**From:** Kajita, Carole, CDA  
**Sent:** Thursday, March 14, 2013 10:13 AM  
**To:** Detterman, Mark, Env. Health  
**Subject:** RE: PLN 2012-00189, CUP, 5269 Crow Canyon Rd., C.V, Continued operation of a light auto repair facility with no proposed changes

Re: **Remedial Action Plan**  
Former Chevron Service Station #9-5607  
5269 Crow Canyon Road  
Castro Valley, California  
Cambria Project No. 31J-1950

Subject: Fuel Leak Case No. RO0000350, Chevron #9-5607, 5269 Crow Canyon Road,  
Castro Valley, CA 94546

MULTI-PHASE EXTRACTION  
SYSTEM LAYOUT  
SITE PLAN/ LAYOUT

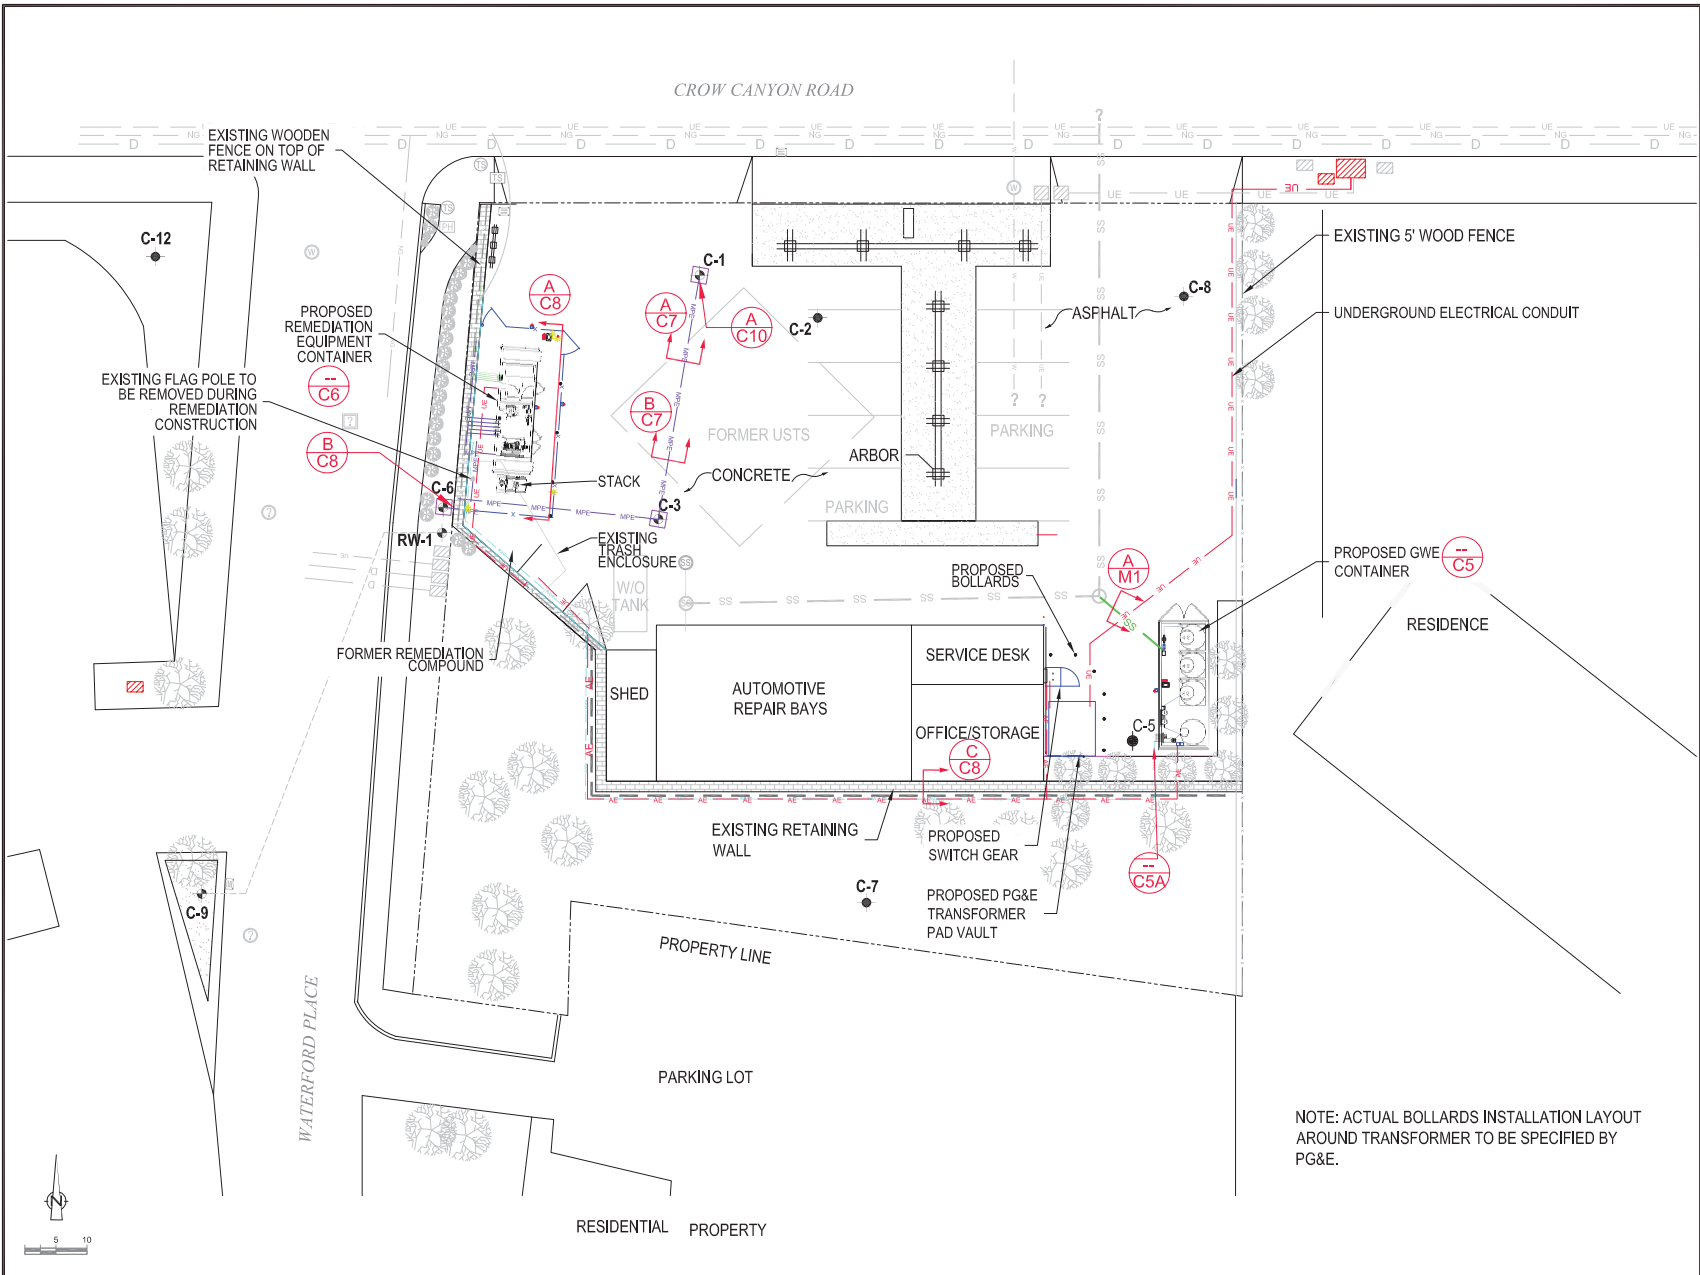
1. The DPE remediation system will be partially located in the southern portion of the site, adjacent to the site building and partially on the northwestern portion of the site adjacent to the retaining wall (see the attached site plan);
2. Connect the DPE remediation system to wells C-1, C-3 and C-6 with underground piping. Based on current groundwater concentrations, connections to wells C-9, C-12, and RW-1 are no longer necessary; and
3. The retaining wall running parallel to Waterford Place will be retrofitted so that it can support the weight of the DPE remediation system.
